DEVELOPMENT REVIEW BOARD REPORT

17-DR-2004
Main Street Mews

Request site plan & elevations approval for a new townhome community

Stipulations for Case: Main Street Mews Case 17-DR-2004

REVISED SITE PLAN

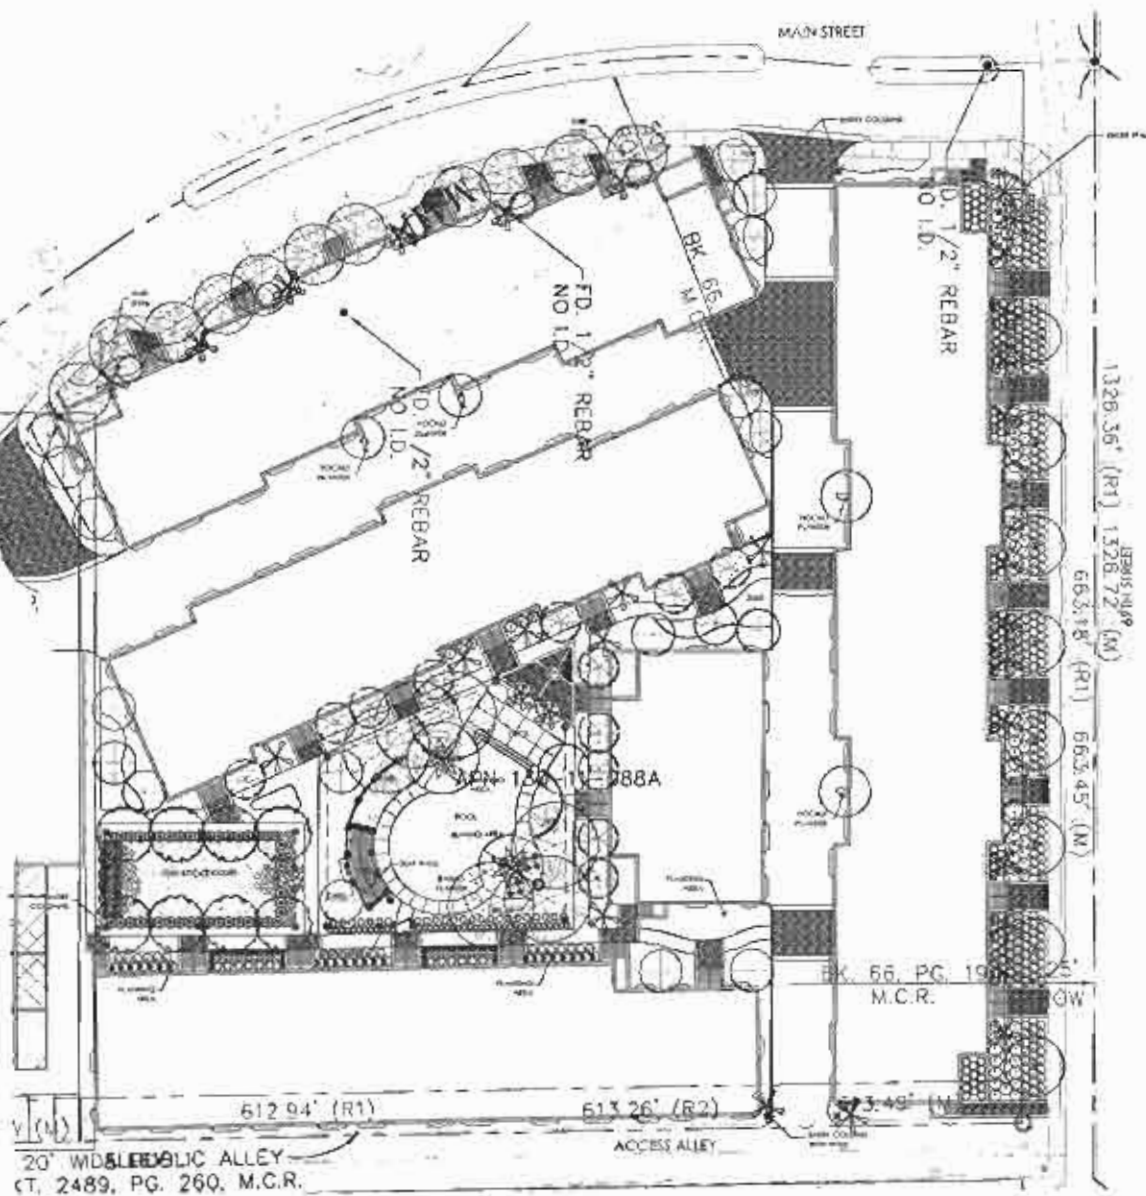
- b. The location and configuration of all site improvements shall be constructed to be consistent with the revised site plan (sheet S-1) submitted by H&S International LLC with a drawing date of 6/21/2004.

ELV-1
K&L International LLC
1000 N. 10th Street
Tulsa, Oklahoma 74103
Phone: (918) 438-1111
Fax: (918) 438-1112
www.kandl.com

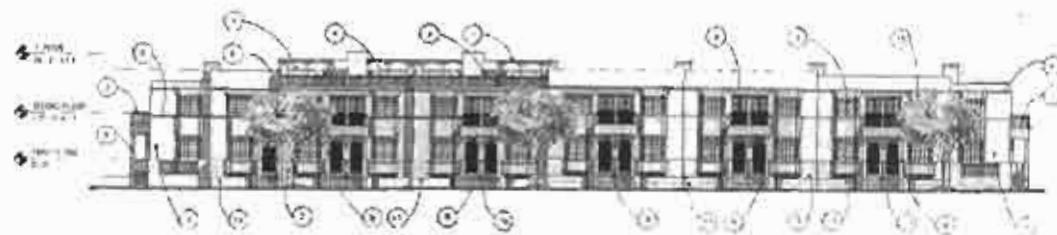
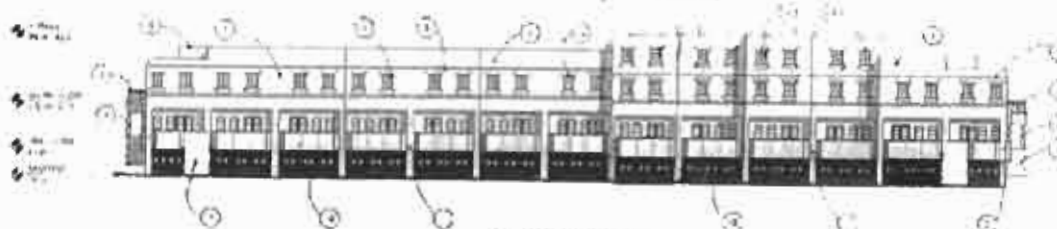
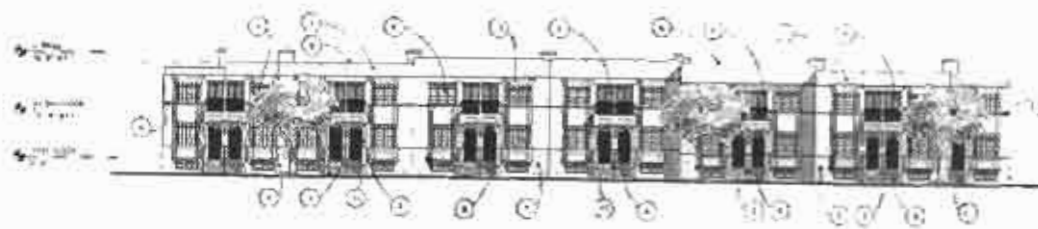
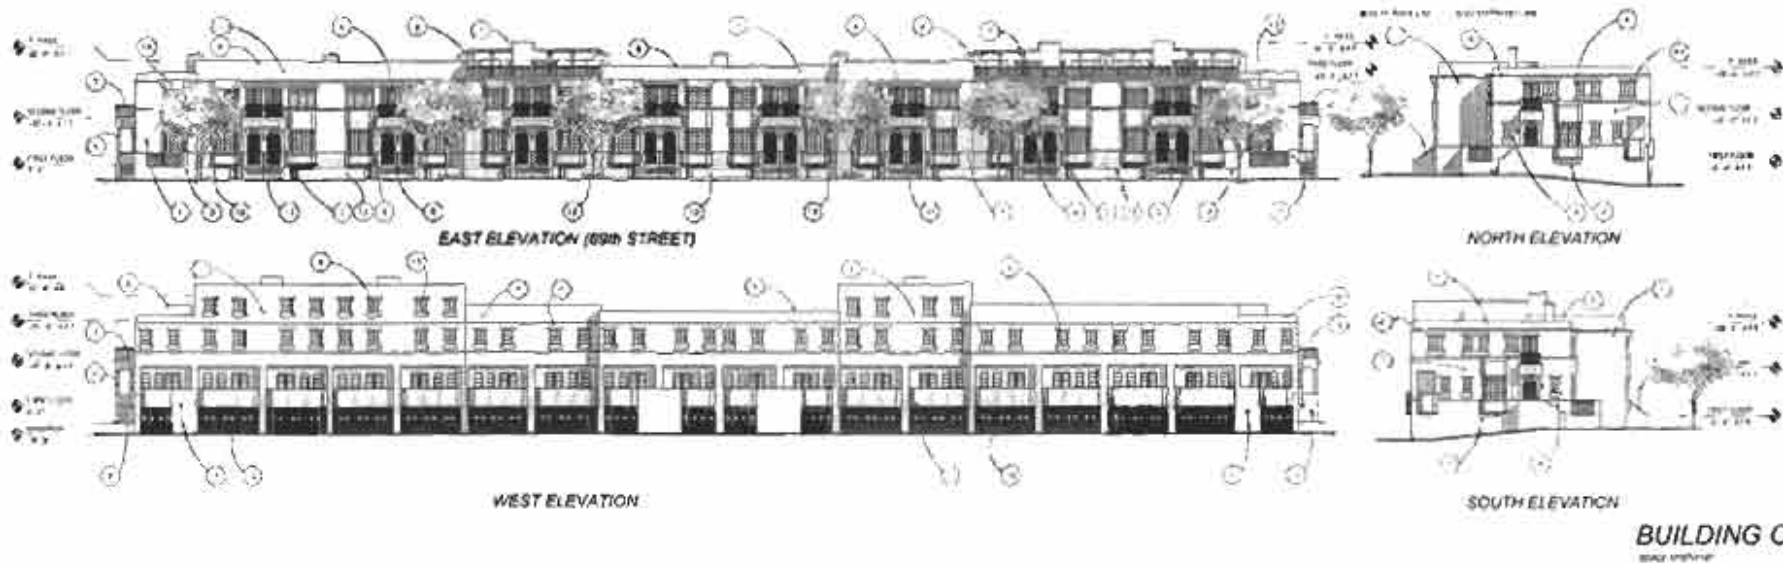
- a. Architectural elements, including dimensions, materials, form, color, and texture, shall be constructed to be consistent with the building elevations (sheets ELV-1, ELV-2, and ELV-3) submitted by H&S International LLC with a drawing date of 6/21/2004.
